WCAP-16793-NP, Rev.0 (Non-Proprietary)
Project No. 694

March 2, 2009

OG-09-84

Subject: Pressurized Water Reactor Owners Group
Responses to the NRC Request for Additional Information (RAI) on WCAP-16793-NP, "Evaluation of Long-Term Cooling Considering Particulate, Fibrous and Chemical Debris in the Recirculating Fluid" (PA-SEE-0312)

Figure 15: Integrated Core Flow vs. Core Boil-off for Uniform $C_D = 50,000$ Case

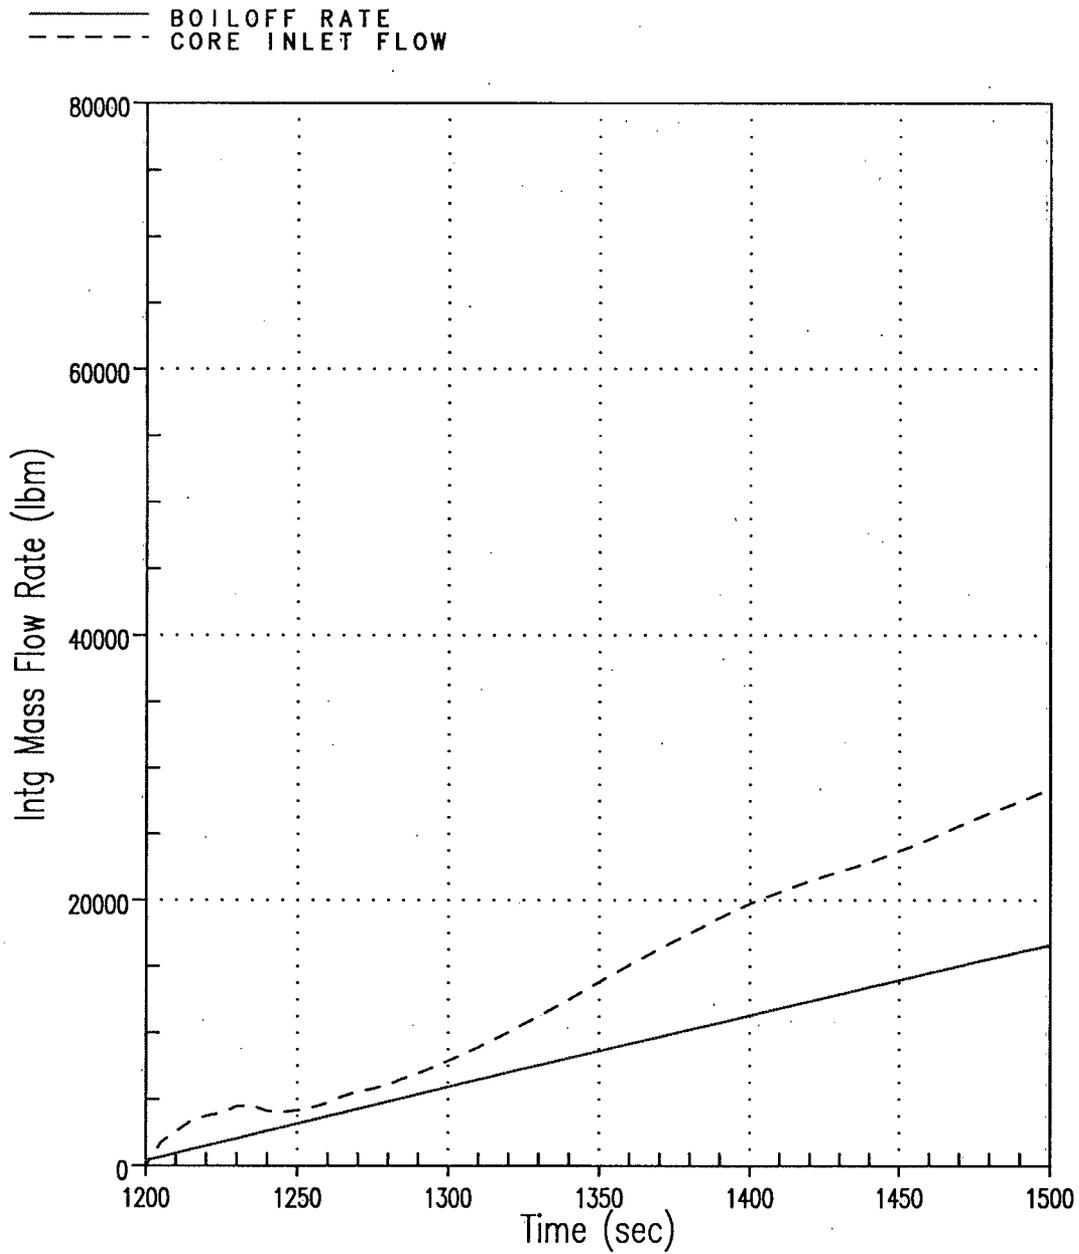
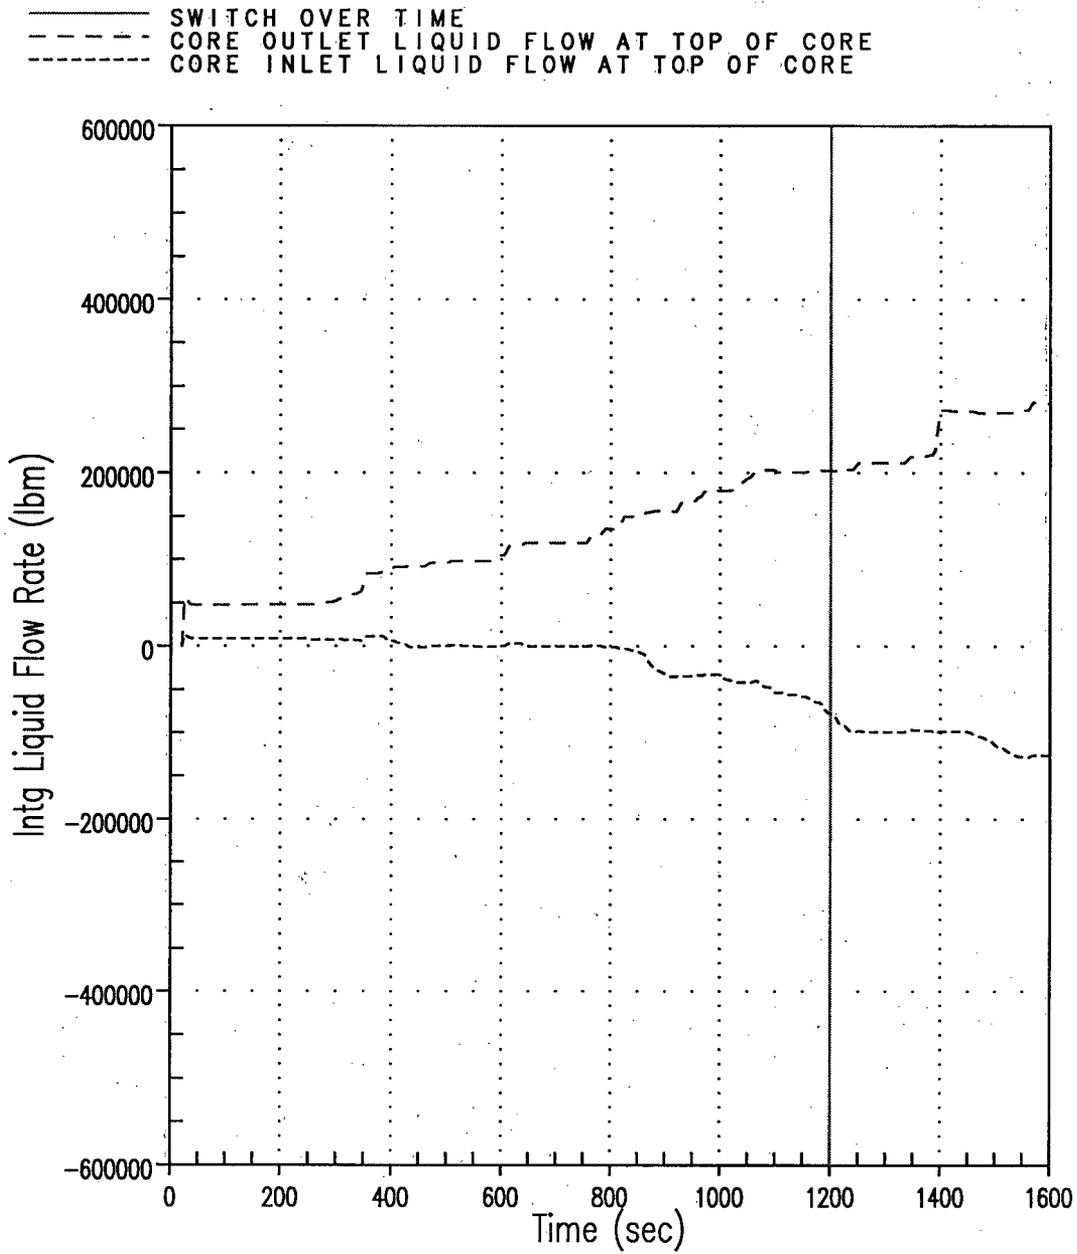
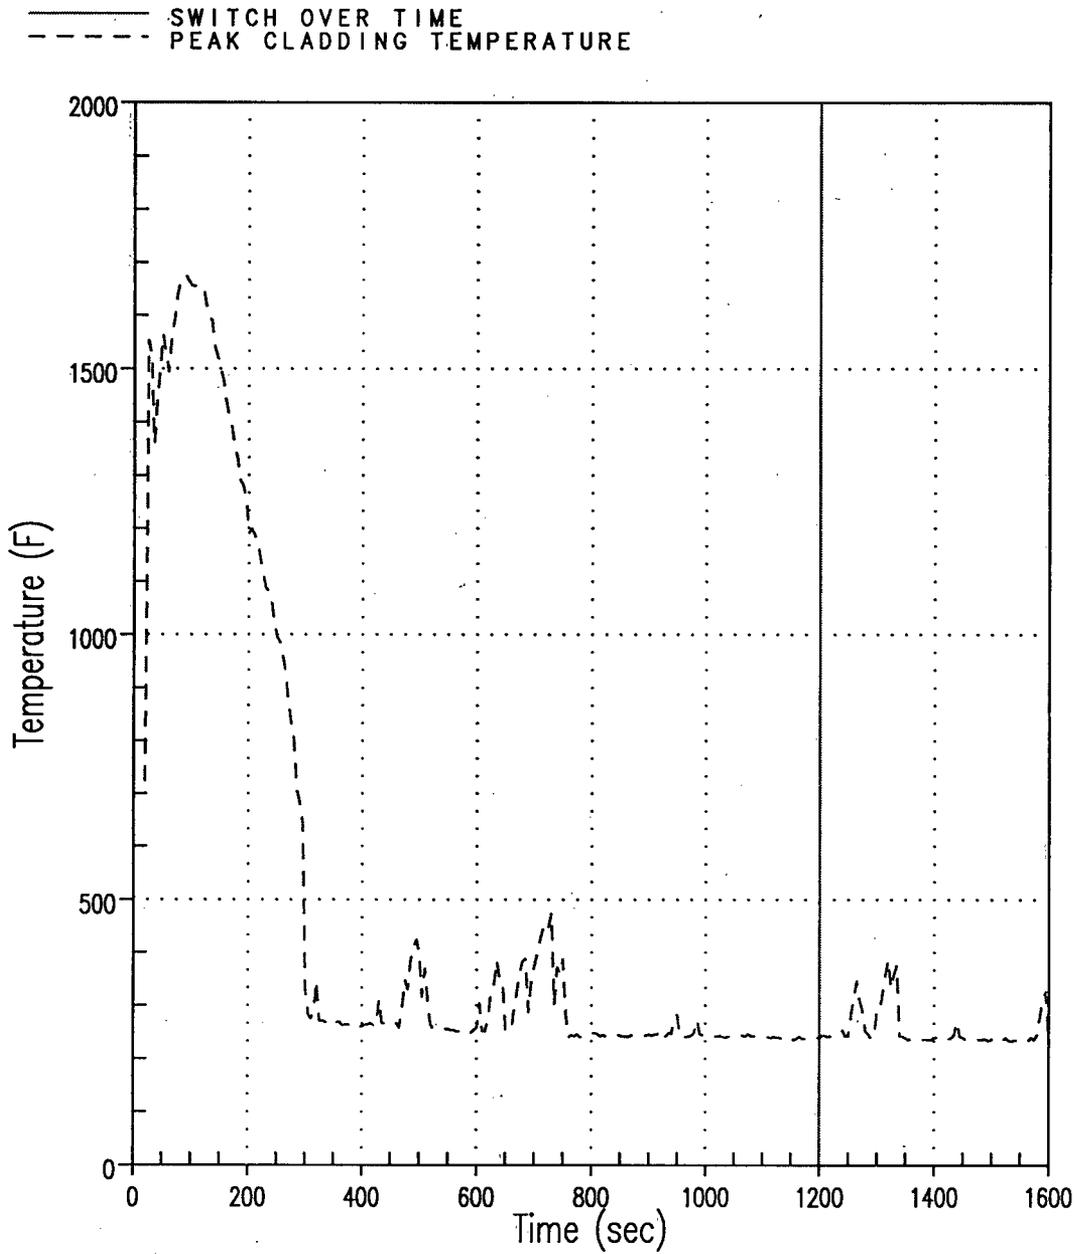
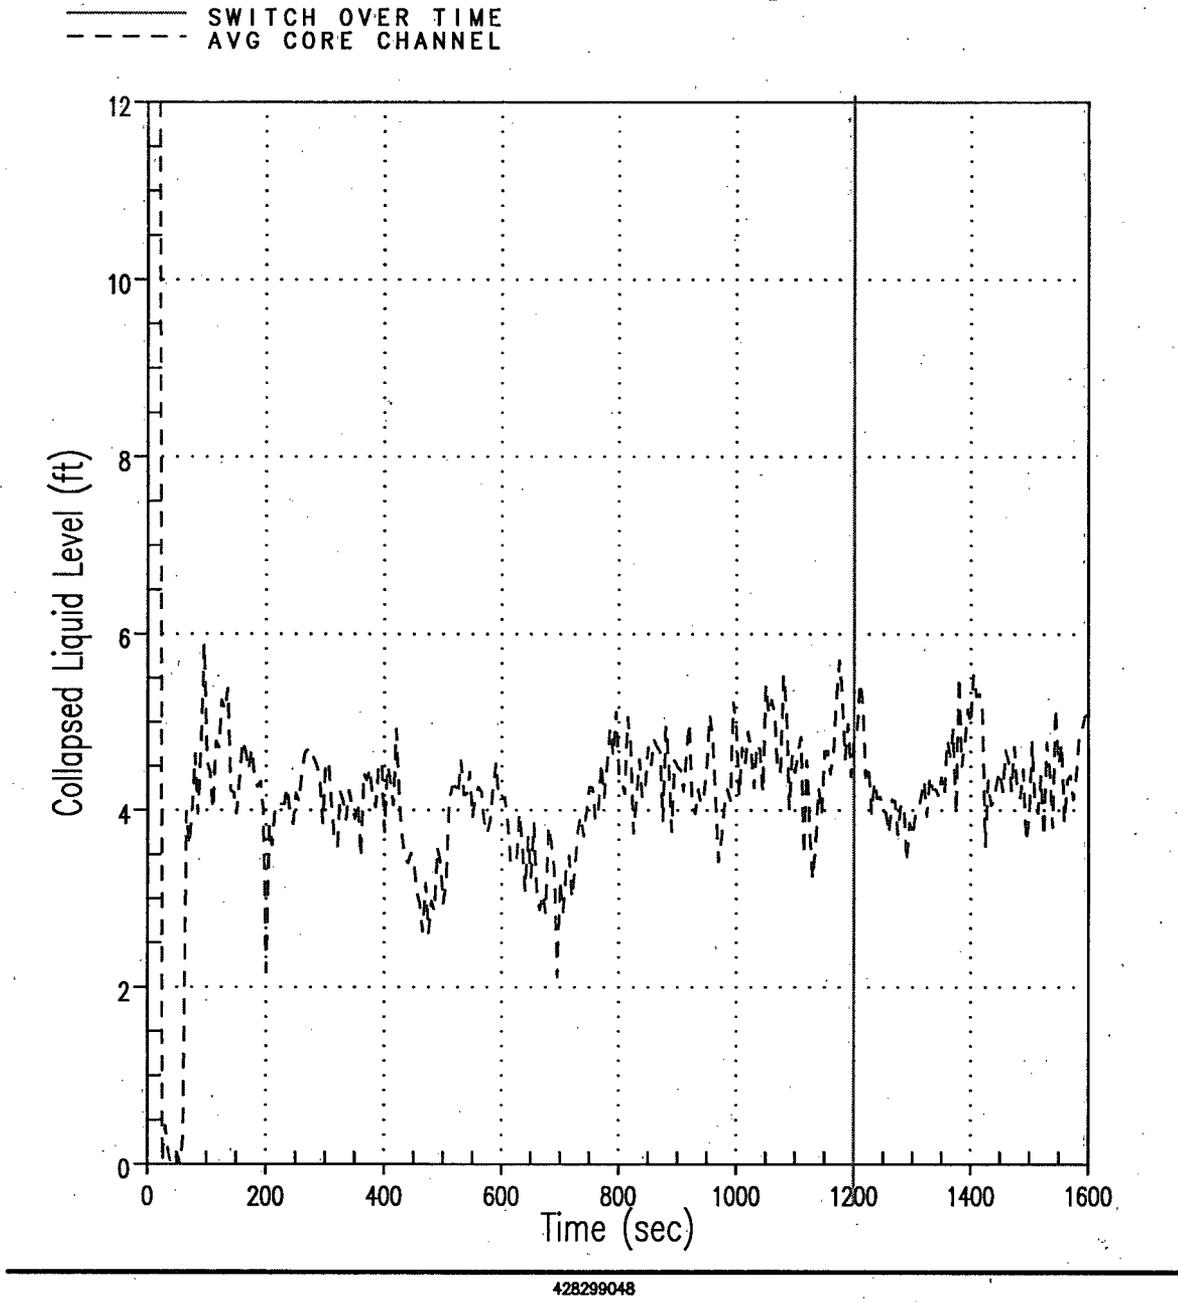
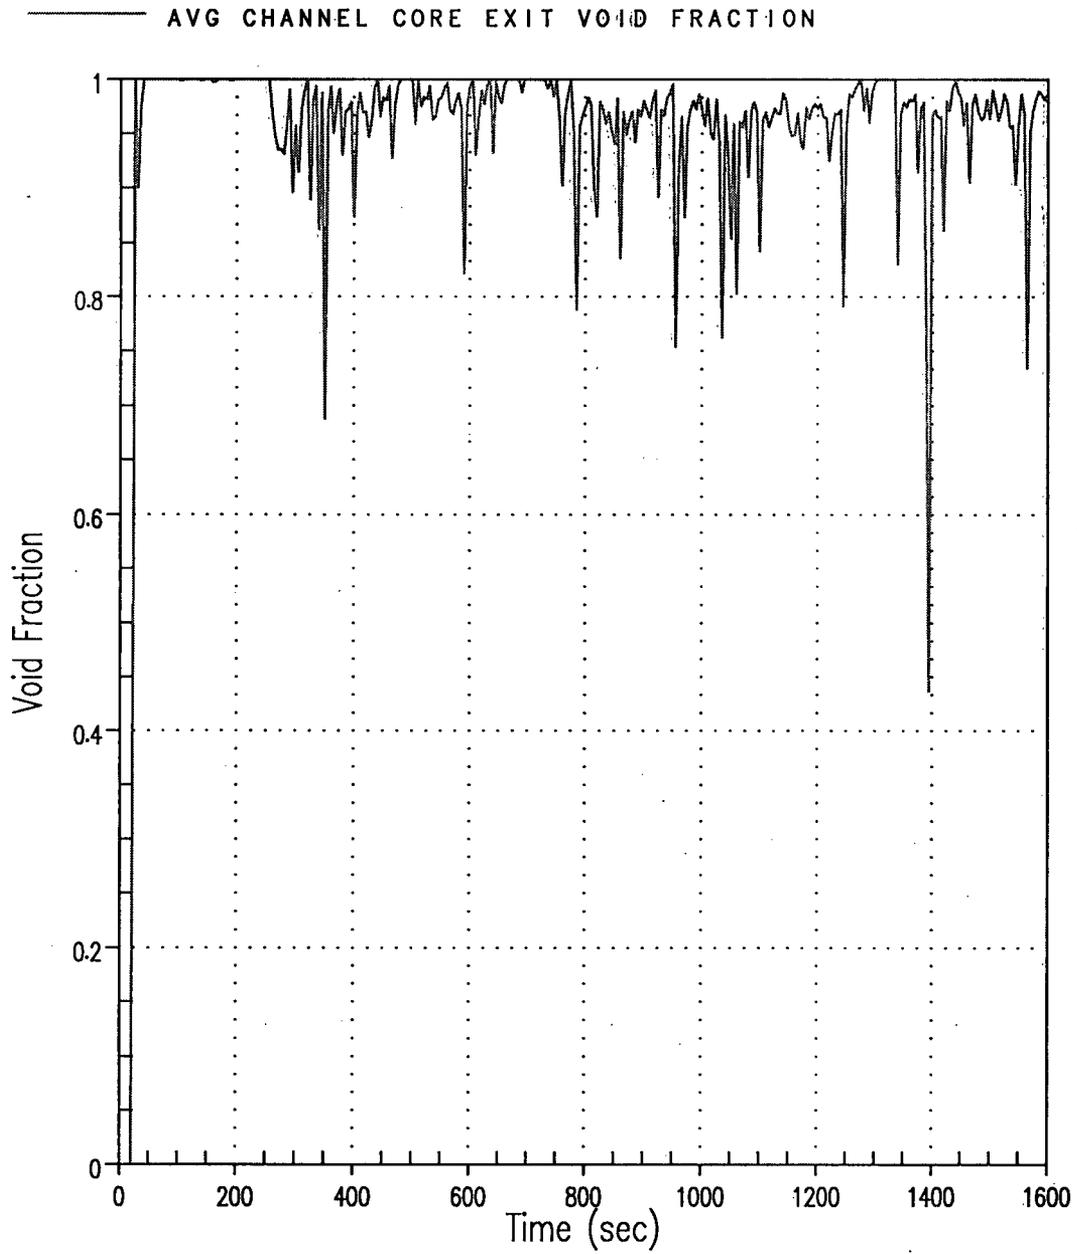
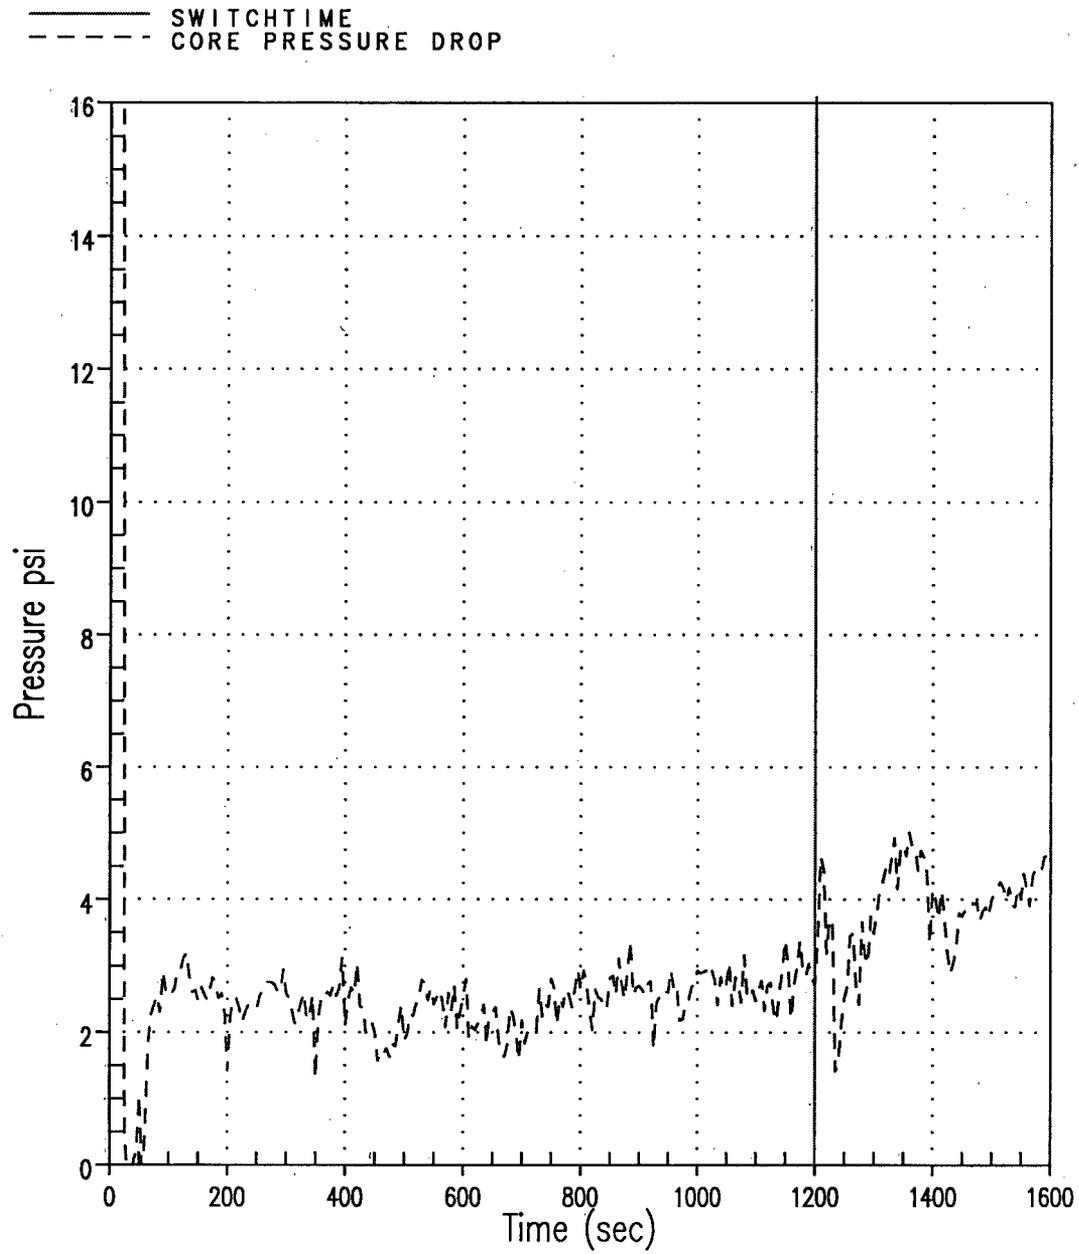
- 1) WCAP-16793-NP, Appendix B, presents analyses of the effect of core inlet blockage using the WCOBRA/TRAC analysis code. Since the report was prepared additional analyses have been performed to determine the blockage level that would reduce core flow below that necessary to match coolant boil-off. Please provide documentation of the additional analyses that have been performed, including figures, for the integrated core inlet and exit flow, peak cladding temperature, core collapsed liquid level, core exit void fraction, and core pressure drop for the bounding conditions. The results should be presented for each case analyzed up to and including the blockage level for which boiloff is no longer satisfied.

The first uniform loss coefficient run performed applied a uniform C_D of 50,000 at the core inlet. The requested plots for this case are shown in Figures 15 through 21. Figures 15 and 16 show comparisons of the integrated core inlet flow and boil-off rate. As shown, even with the increase of the loss coefficient at the inlet, the flow that enters the core is still in excess of the boil-off rate. (Note that the integrated mass flow behavior shown between time $t = 1200$ seconds and time $t = 1250$ seconds of Figure 16 is the result of the 30 second ramp-up of the hydraulic loss coefficient, C_D , to 50,000 that is initiated in the calculations at time $t = 1200$ seconds.) Figure 17 displays the integrated liquid flow at the core exit. The figure displays that liquid in excess of that needed to keep the core quenched enters the core and that liquid flow is present at the top of the core even after the increase of the loss coefficient at the inlet. The PCT is shown in Figure 18. There are no significant PCT excursions after the core inlet loss coefficient is increased. Figure 19 displays the collapsed liquid level of the average assembly core channel (Channel 11 of Figure 6.3.4-3 in Reference 1). The figure shows that the collapsed liquid level drops slightly at time blockage occurs, however, the liquid is maintained even after the increase in the loss coefficient at the inlet. The void fraction at the core exit shown in Figure 20 again illustrates that liquid is present at the top of the core which shows the flow that enters the core after the increase of the loss coefficient occurs is still in excess of the boil-off rate. The core pressure drop is displayed in Figure 21. The figure displays an increased pressure drop of roughly 2 psi as blockage at the core inlet is increased. As the conditions in the Reactor Coolant System (RCS) adjust to increase in core blockage, it is noticed that the core pressure drop fluctuates consistent with the core liquid level.
